Re: Palomino Roofing, 6910 Huseman SW
Request for Permanent C.O. –Accepted
Engineer's Stamp dated: 5-9-07, (M10D016F)
Certification dated: 6-17-14

GRADING AND DRAINAGE PLAN
PALOMINO ROOFING CO.
6910 HUSEMAN DRIVE

RED-LINE AS-BUILT PREPARED BY:

GRADING AND DRAINAGE PLAN
PALOMINO ROOFING CO.
6910 HUSEMAN DRIVE SW

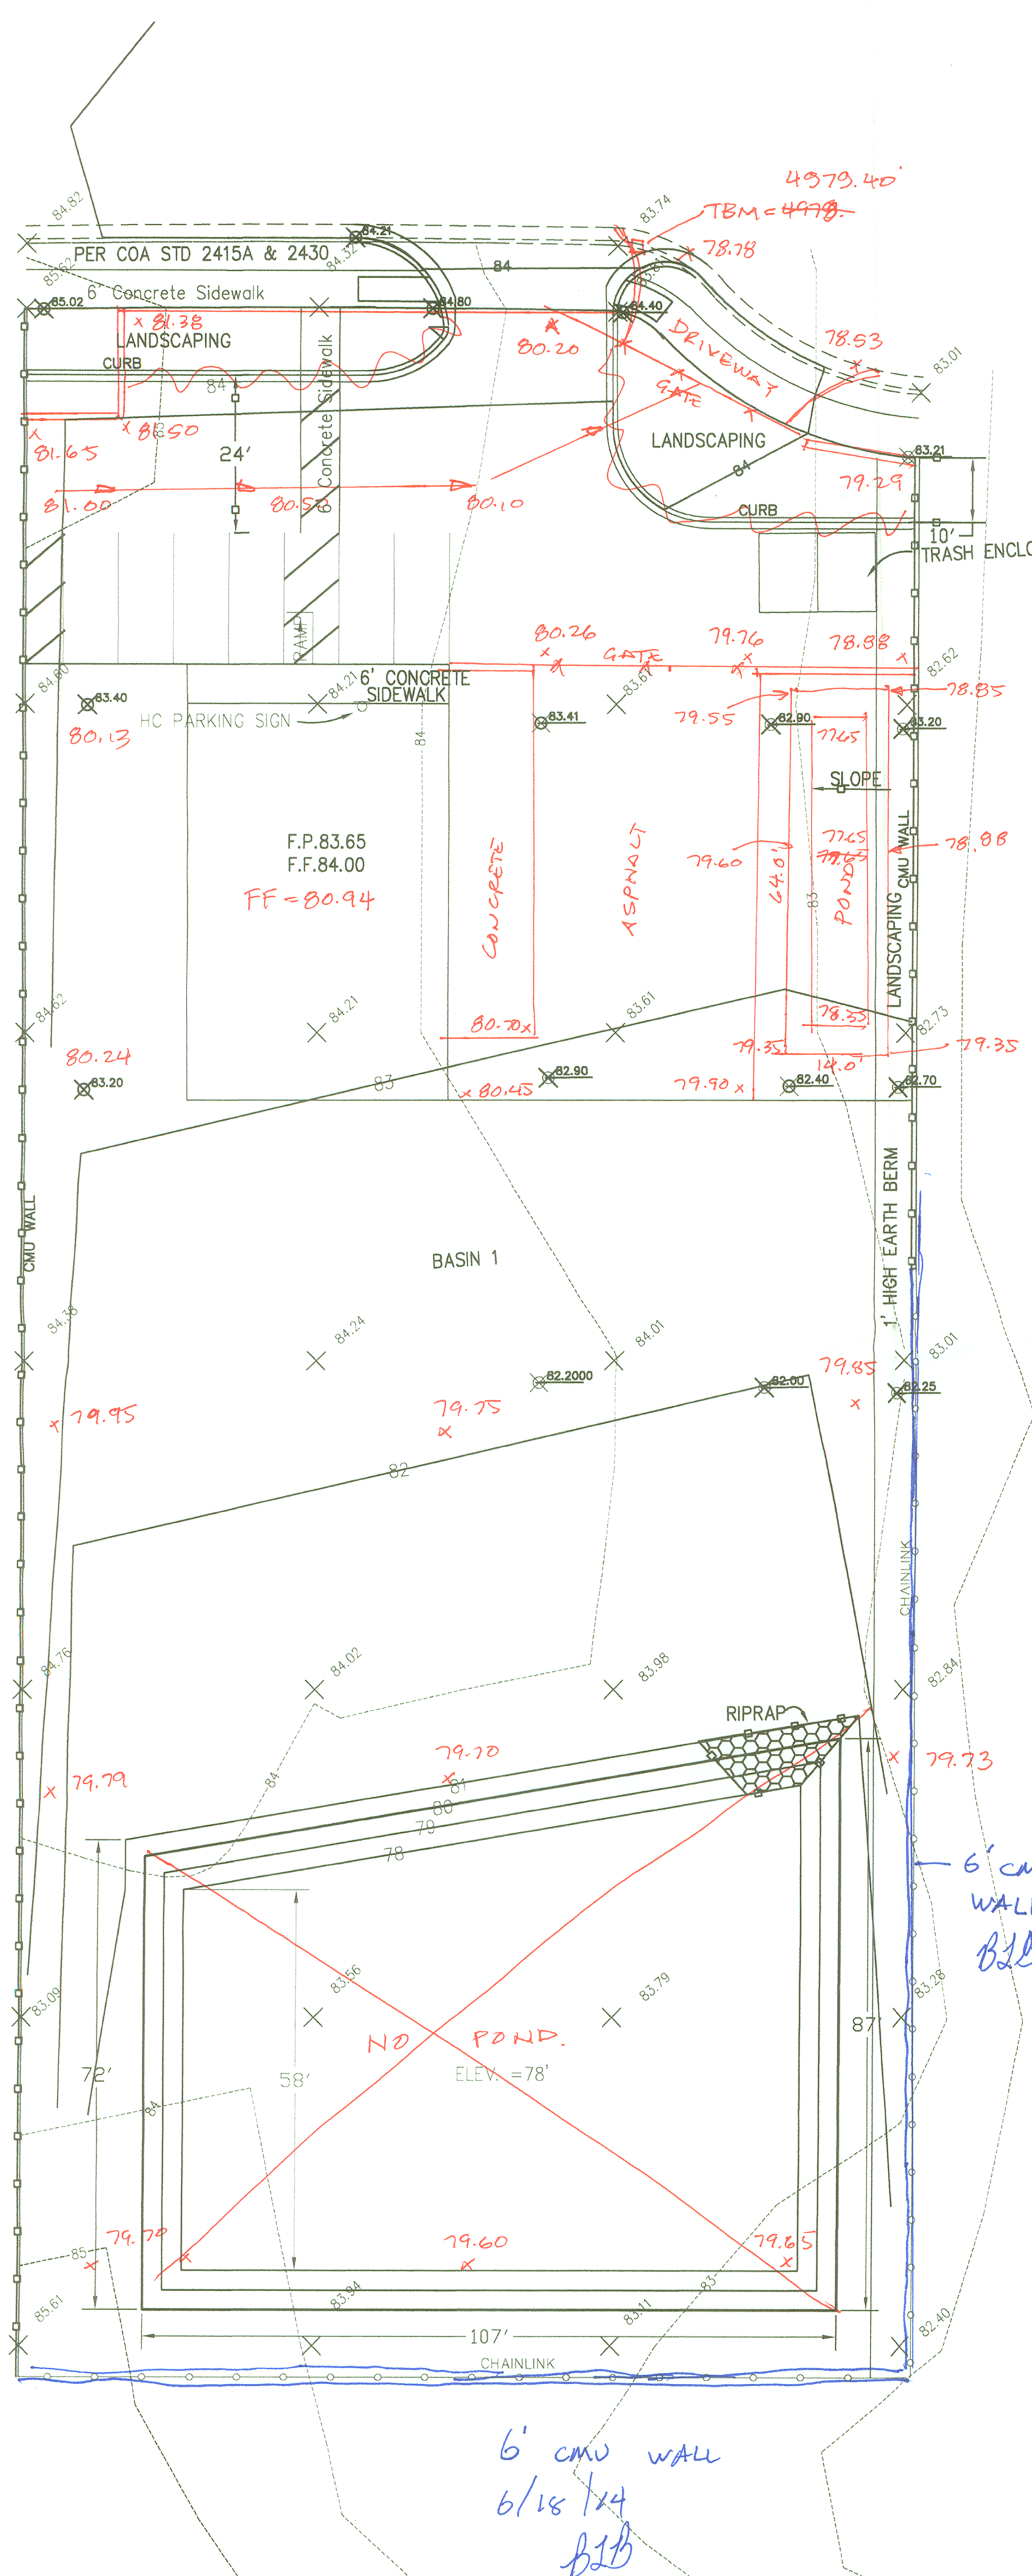
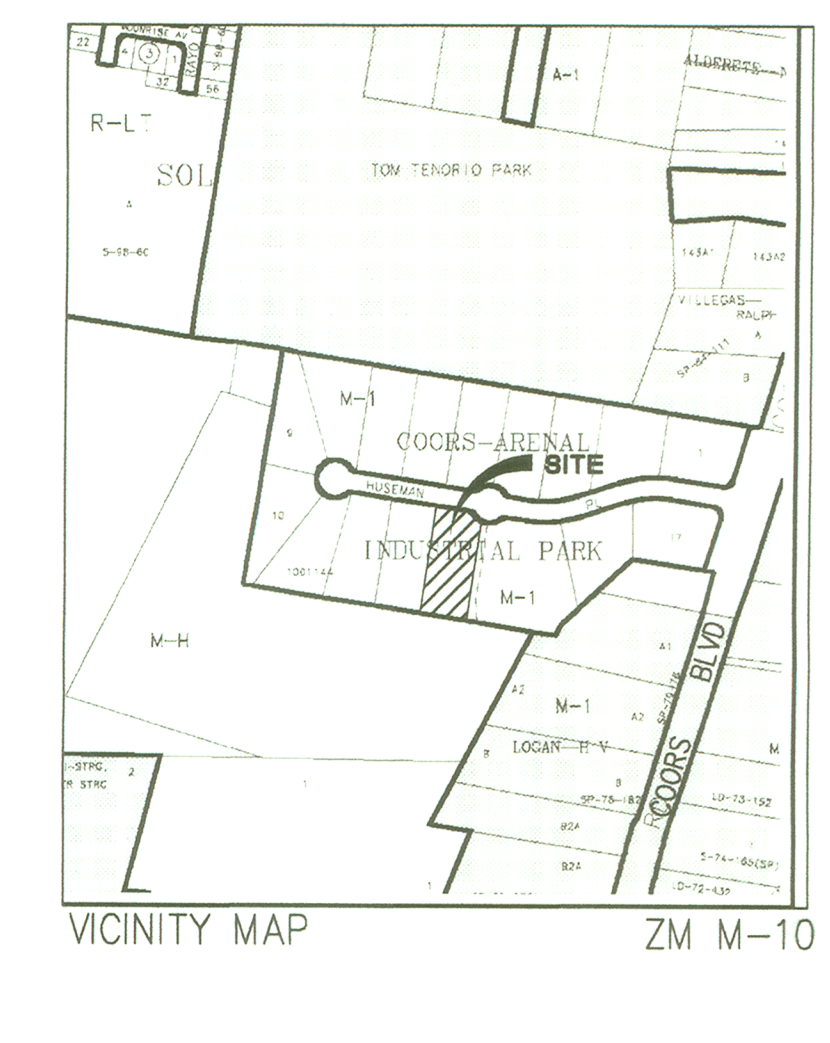
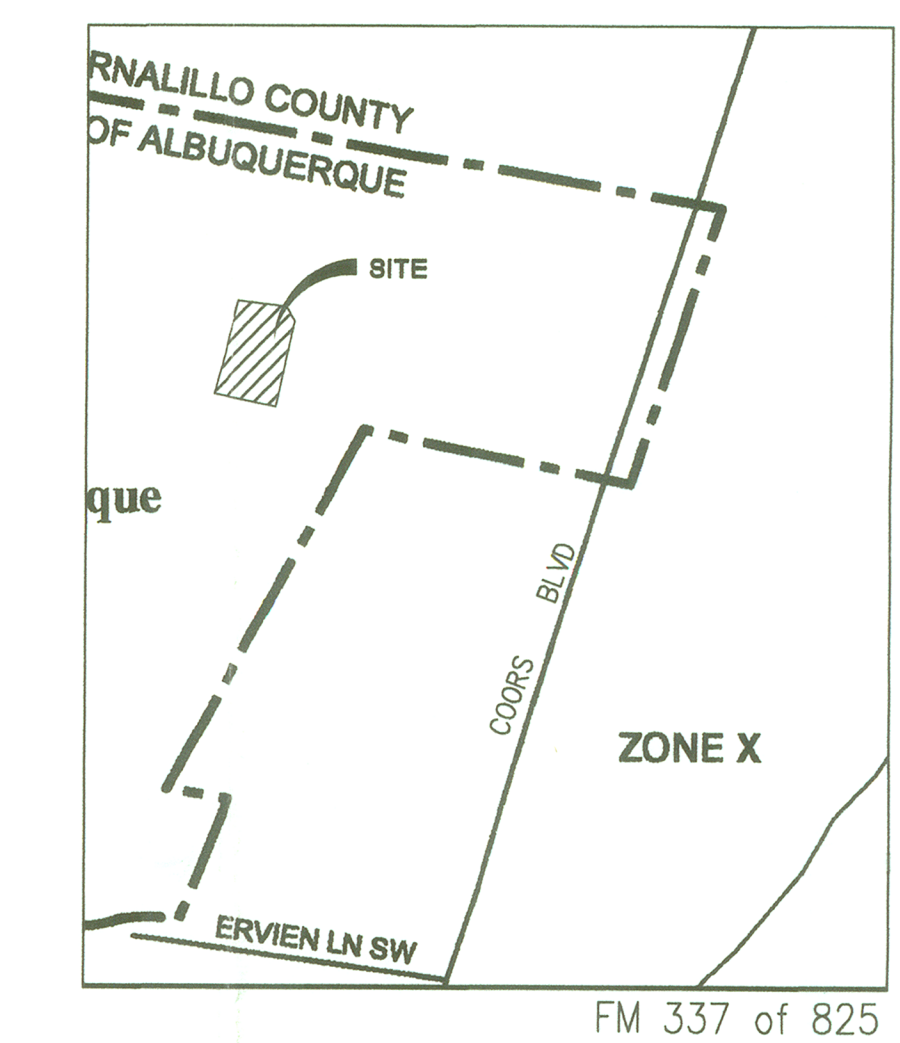
The site was modified somewhat from the original plan. The driveway was move further east and the pond was constructed north of the originally proposed location. Fully grouted CMU wall constructed along entire perimeter of property. Required volume = 6374 cu.ft. Pond volume provided = 4750 cu.ft. which handles the impervious portion of the site. The remaining volume generated in the southern, unpaved portion is retained in place and kept from leaving the site by the fully grouted CMU wall.
